# UNITED STATES PATENT AND TRADEMARK OFFICE

APPLICATION NO.	FILING DATE	FIRST NAMED INVENTOR	ATTORNEY DOCKET NO.	CONFIRMATION NO.
10/045,017	01/15/2002	Yoshitaka Terao	P56664	7888

### Office Action Summary

## **DETAILED ACTION**

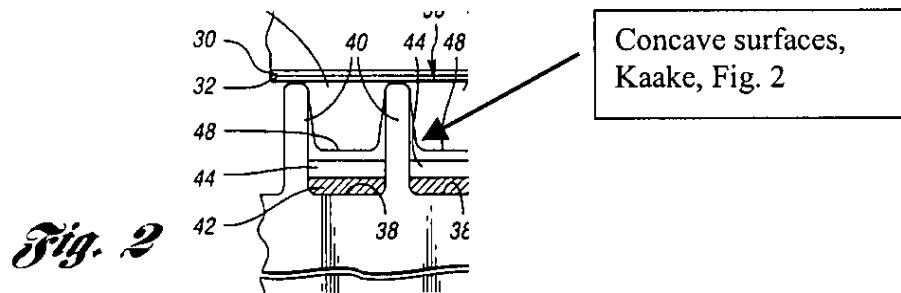
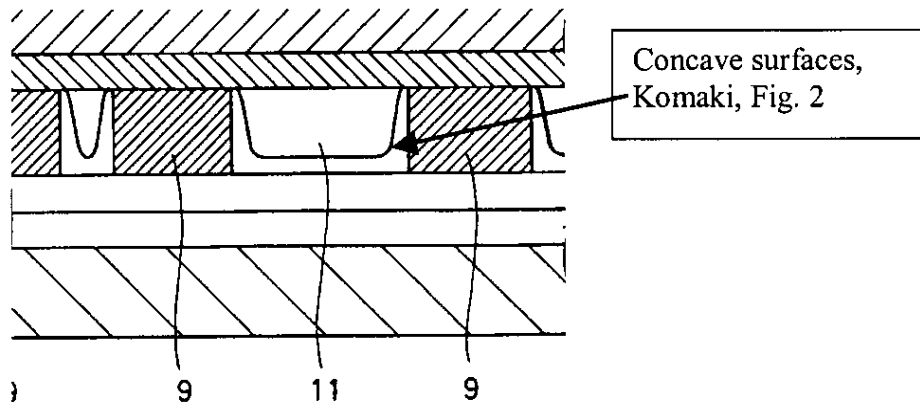
45. Sixth, in response to Applicant's argument concerning claim 10, that the Examiner makes no mention of the partitioned discharge cell being of a certain width to correspond to the color displayed, and that Kaake teaches away from concave surface, the Examiner respectfully directs Applicant to paragraph 27 of the previous Office Action. The Examiner states that Komaki shows "a width of each of the partitioned discharge cells are formed to correspond to a color displayed by the particular portioned discharge cell." Furthermore, both Kaake and Komaki show the discharge cells include concave surfaces (below).
